# Product/Process Change Notice (PCN)

PCN #:  
PCN\_FeStarFix/FixLFS/Gap/Bueno\_20150130\_Packaging-Change

Product Affected: 74271633, 74271633S,  
74271733, 74271733S, 74272733, 74275813,  
74275813S

## DETAIL OF CHANGE:

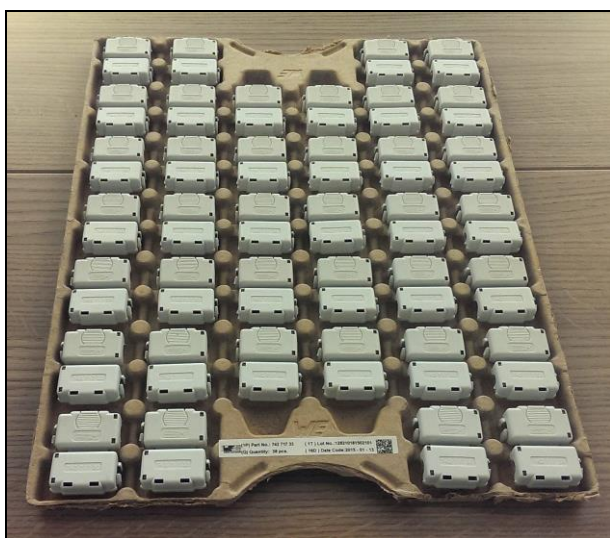
Tray design and size change for improved handling and transport.  
Dimensions change as detailed in the tables below.

Due to size and design change of the tray, the packing size and packing quantity will change as detailed in the tables below. Carton box material will remain double wall corrugated cardboard.

**Vibrations test setup**

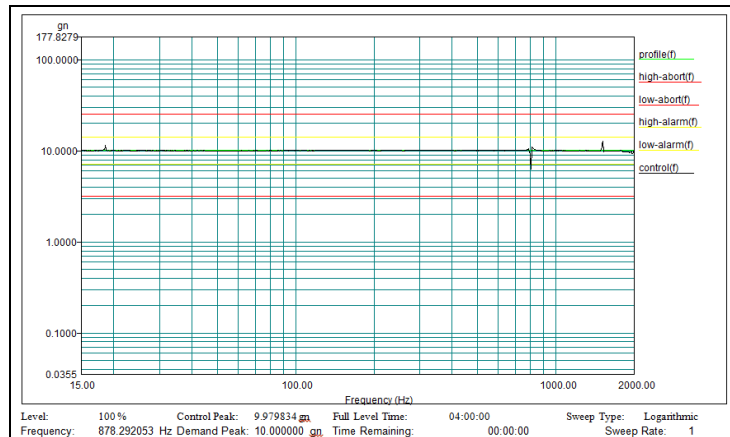
1. Drop test according to *DIN EN 22248 "Packaging; complete, filled transport packages; vertical impact test by dropping (ISO 2248:1985)"* has been done.
2. Vibrations test according to *MIL-STD-202 Method 204* has been done under the following test conditions:  
 Acceleration: 10G  
 Frequency range: 15-2000Hz  
 Duration: 4 hours at Z axis
